GEN-2017-150 Modification Request Impact Study

Revision R1 September 8, 2026

Submitted to
SPP

Figure 2-2: GEN-2017-150 Single Line Diagram (Modification Configuration)

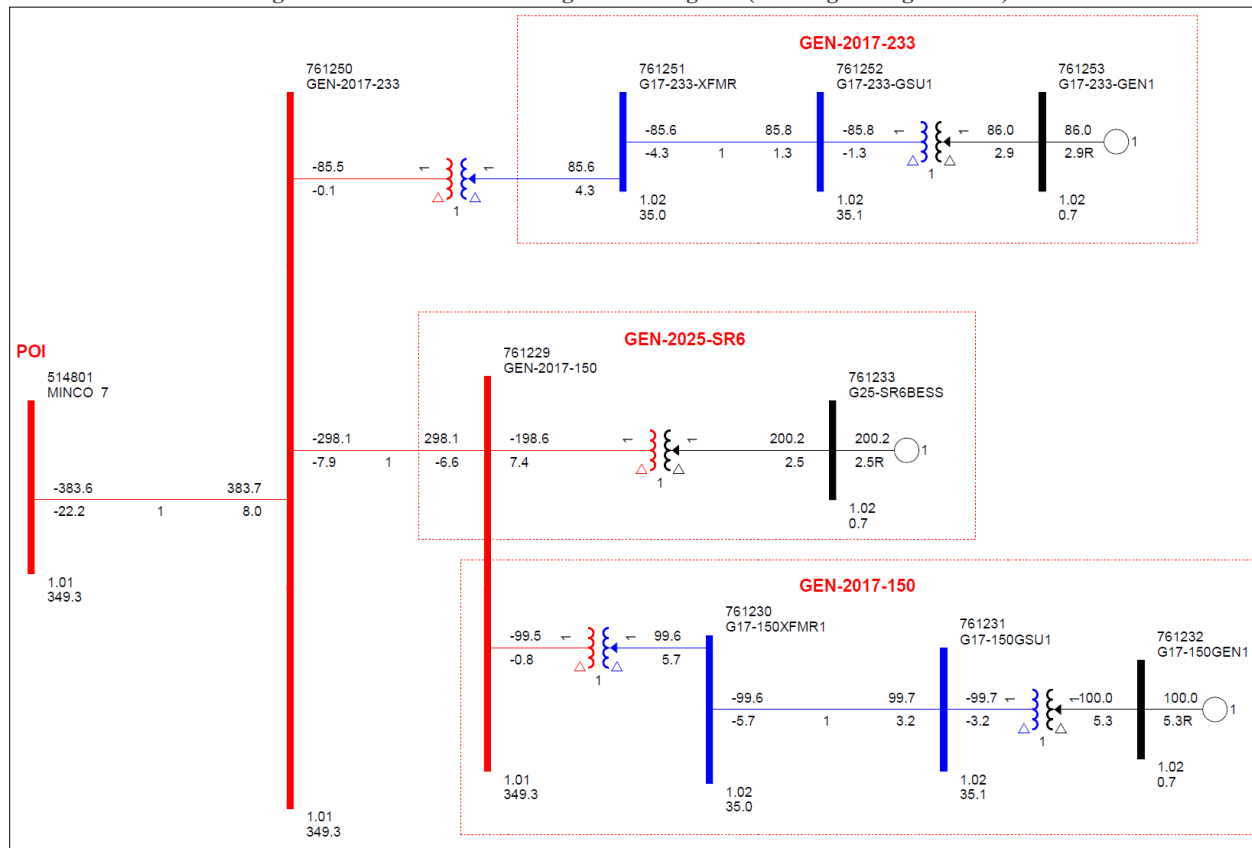
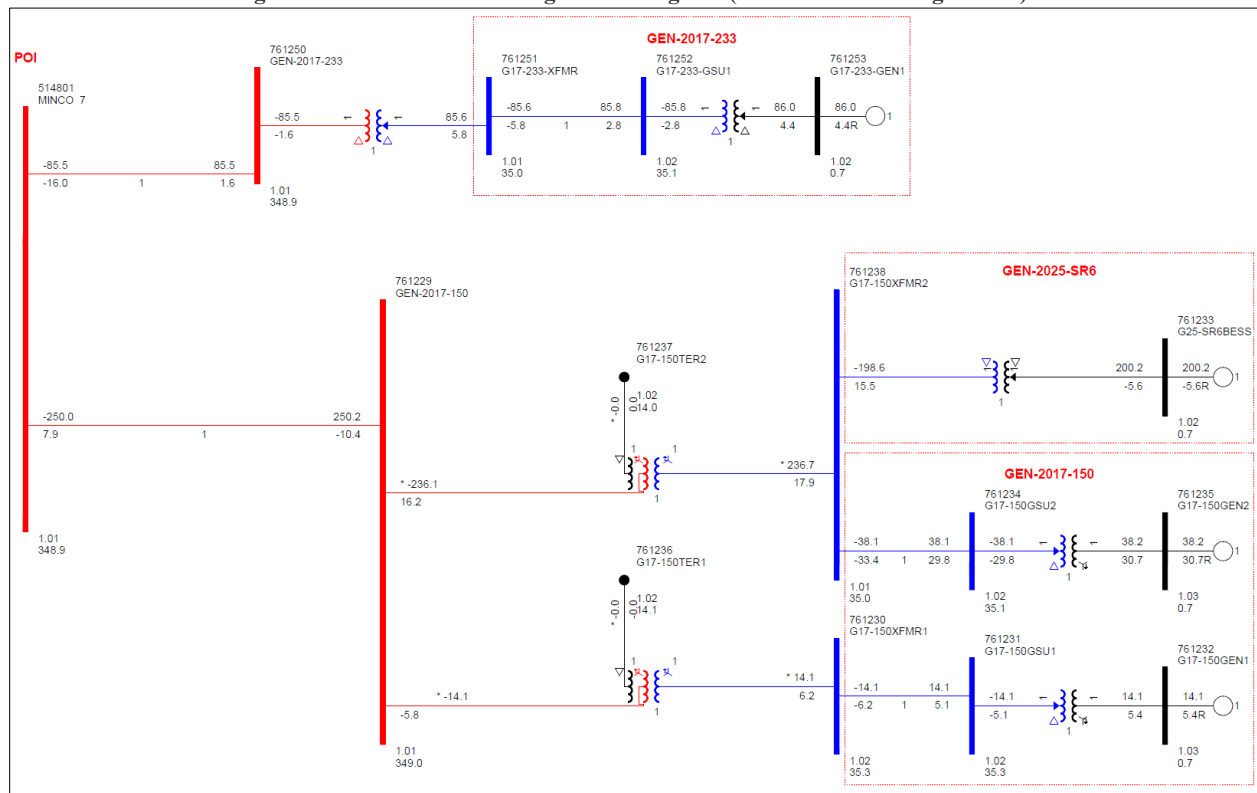
This Study has been requested to evaluate the modification of GEN-2017-150 to change the configuration to 74 x PE 3.42 MW solar inverters operating at 3.42 MW for a total assumed dispatch of 253.08 MW. The inverters have a generating capability that exceeds its Generator Interconnection Agreement (GIA) Interconnection Service amount. The injection amount must be limited to 250 MW at the POI as listed in Appendix A of the GIA. As a result, the customer must ensure that the amount of power injected at the POI does not exceed the Interconnection Service amount listed in its GIA. The requested modification includes the use of a Power Plant Controller (PPC) to limit the total power injected into the POI.

In addition, the modification request included changes to the collection system, generator step-up transformers, main substation transformers, and generation interconnection line. Figure 2-2 shows the power flow model single line diagram for the GEN-2017-150 modification with the GEN-2025-SR6 surplus project included. The existing and modified configurations for GEN-2017-150 are shown in Table 2-1 below.

Figure 4-1: GEN-2017-150 Single Line Diagram (Shunt Sizes)

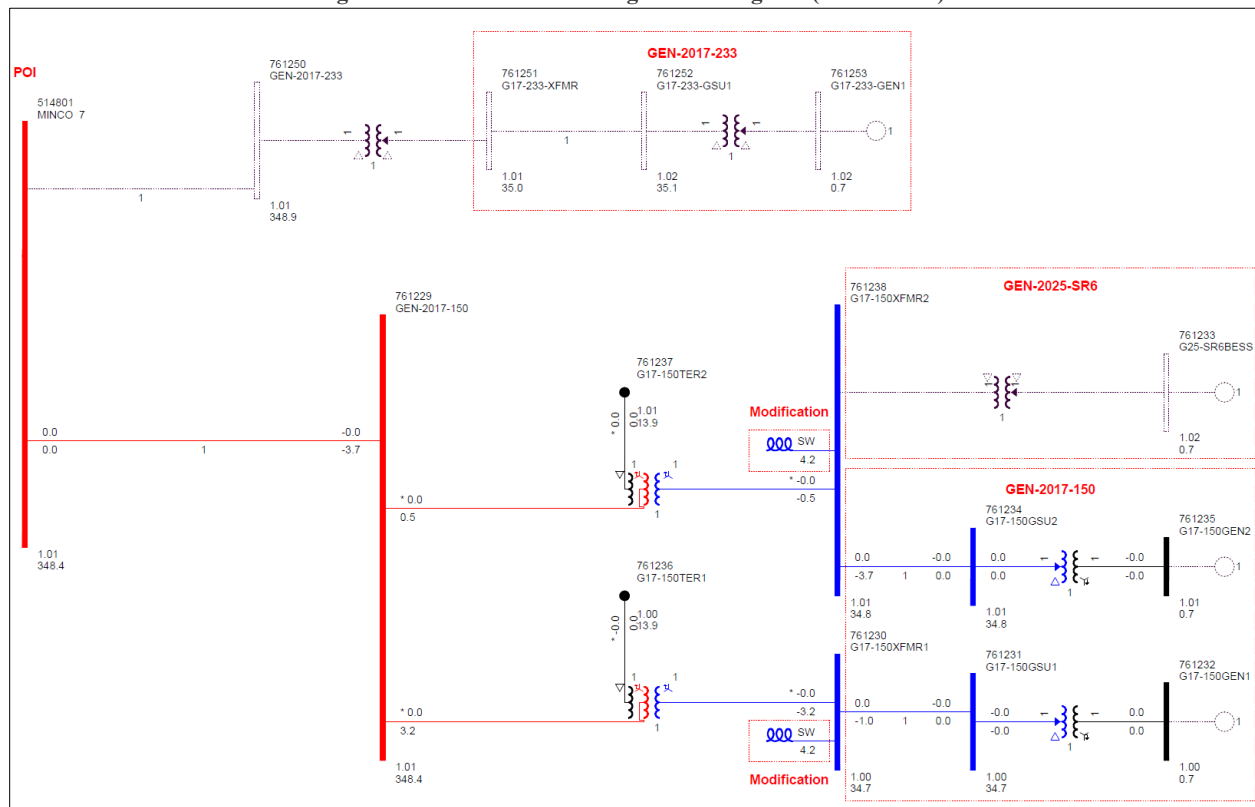
The results from the analysis showed that the GEN-2017-150 project needed approximately 8.3 MVar of compensation at its collector substation to reduce the MVar injection at the POI to zero. This is a decrease from the 16.92 MVar found in the DISIS-2017-002-2 study³. The final shunt reactor requirements are shown in Table 4-1. Figure 4-1 illustrates the shunt reactor size needed to reduce the POI MVar to approximately zero with the updated topology.
